**PLANNED UNIT DEVELOPMENT  
& SUBDIVISION STAFF REPORT****Date: May 18, 2017****DEVELOPMENT NAME**

Ryerson Subdivision

Planned Unit Development Approval to allow multiple  
buildings on a single building site with reduced setbacks,  
and Subdivision approval to create one legal lot of record.

# SITE PLAN

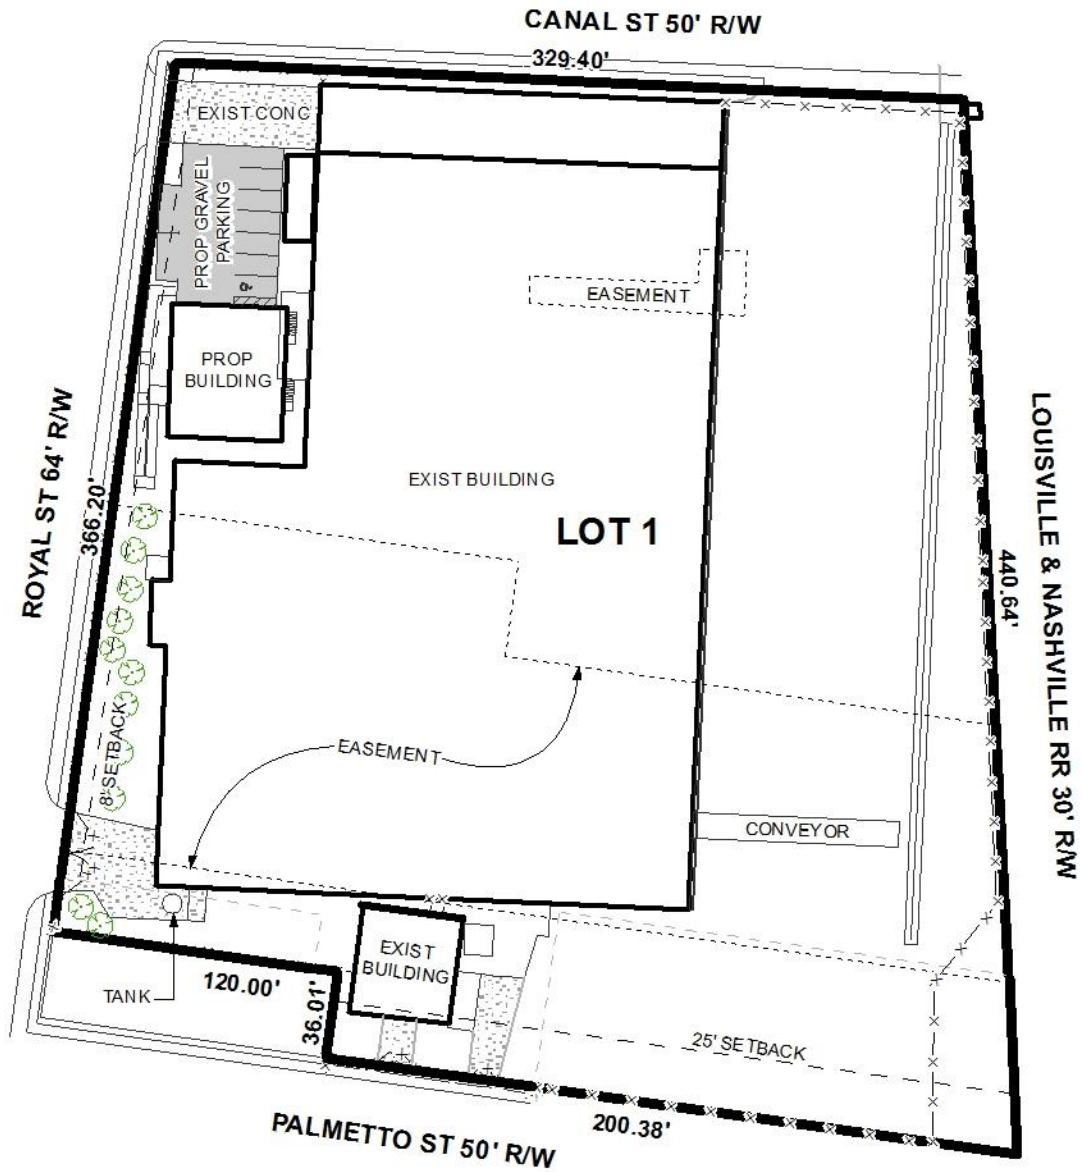
Site is limited to its existing curbs cuts with size, location and design to be approved by Traffic Engineering and conform to AASHTO standards. Any new on-site parking, including ADA handicap spaces, shall meet the minimum standards as defined in Section 64-6 of the City's Zoning Ordinance. The handicap parking as shown does not meet minimum width requirements for a van accessible space (16' minimum).

As the site is zoned I-2, the current use is allowed by right. Furthermore, this district allows up to 75% building site coverage and a 25' front yard setback and zero or 5'+ side and rear yard setbacks (when abutting other commercial districts). The site plan indicates one existing modular office building to be removed and replaced with a larger one encroaching into the 25' front setback along South Royal Street. With the proposed modular building added and one existing modular building removed, the site would have a compliant total site coverage of approximately 47%. With the site being in an older industrial area with many existing noncompliant setbacks, and with the recently-approved setbacks approved by the Commission directly across South Royal Street, the allowance of the requested reduced setbacks would not be out of character for the area. The site plan for the PUD should be revised to reflect the setbacks as allowed for the Subdivision.

Parking calculations on the site plan are for office space only and indicate a sufficient number of spaces provided. However, no calculations are provided for warehouse employees. Therefore, the site plan parking calculations should be revised to provide sufficient parking for warehouse employees also and to indicate such parking spaces on site. It should be noted that, if the site is required to have more than 25 parking spaces, a photometric lighting plan for the parking area will be required at the time of submittal for development permits. As the site is within an I-2

Landscaping calculations indicate compliance with the ratio requirements. However, as only a small portion of the site is proposed for re-development, staff has determined that tree plantings can be based on only the affected 170' of South Royal Street frontage, thereby requiring only five frontage trees.

The site plan does not indicate a dumpster nor is there a note stating that a dumpster will not be utilized. Therefore, the site plan should be revised to indicate a compliant dumpster or a note should be placed on the site plan stating that refuse collection will either be via private can collection or curb-side service.

The site plan should be revised to indicate any required corner radius dedication at the intersection of South Royal Street and Canal Street as per the Subdivision. The lot area label should also be revised to reflect the lot size in both square feet and acres after any required dedication, or a table should be furnished on the site plan providing the same information.

The site plan indicates public sidewalks along most of the public street frontages. However, no sidewalks are indicated along the Eastern ends of the site along Canal Street or Palmetto Street. Therefore, the site plan should be revised to indicate sidewalks along all public street frontages, or a Sidewalk Waiver should be approved prior to signing the Final Plat for the Subdivision.

- 1) retention of the 8' minimum building setback line along the South Royal Street frontage;
- 2) revision of the site plan to illustrate a minimum building setback line along the North face of the existing building and expanding to 25' to the East and West of the building footprint;

- 3) retention of the 25' minimum building setback line along Palmetto Street adjusted to be along the face of the existing Quonset hut building within that encroachment;

- 4) revision of the site plan to illustrate a zero or 5'+ building setback line along the East side of the site adjacent to the railroad right-of-way;

- 5) revision of the parking calculations to provide sufficient parking for warehouse employees and provision of additional parking spaces on the site plan, if needed;

- 6) revision of the site plan to provide five frontage trees based on the 170' frontage of the proposed affected area instead of the entire Royal Street frontage, with the location to be coordinated with the Planning and Zoning staff;

- 7) placement of a note on the site plan stating that the lot is limited to its existing curb cuts, with the size, location and design to be approved by Traffic Engineering and conform to AASHTO standards;

- 8) revision of the site plan to indicate a compliant dumpster or the placement of a note on the site plan stating that refuse collection will either be via private can collection or curb-side service;

- 9) revision of the site plan to provide a 25' corner radius dedication at the corner of South Royal Street and Canal Street;
- 10) revision of the site plan to label the lot size in both square feet and acres after any required dedication, or the furnishing of a table on the site plan providing the same information;

- 11) revision of the site plan to indicate sidewalks along all public street frontages, or the approval of a Sidewalk Waiver prior to signing the Final Plat for the Subdivision;
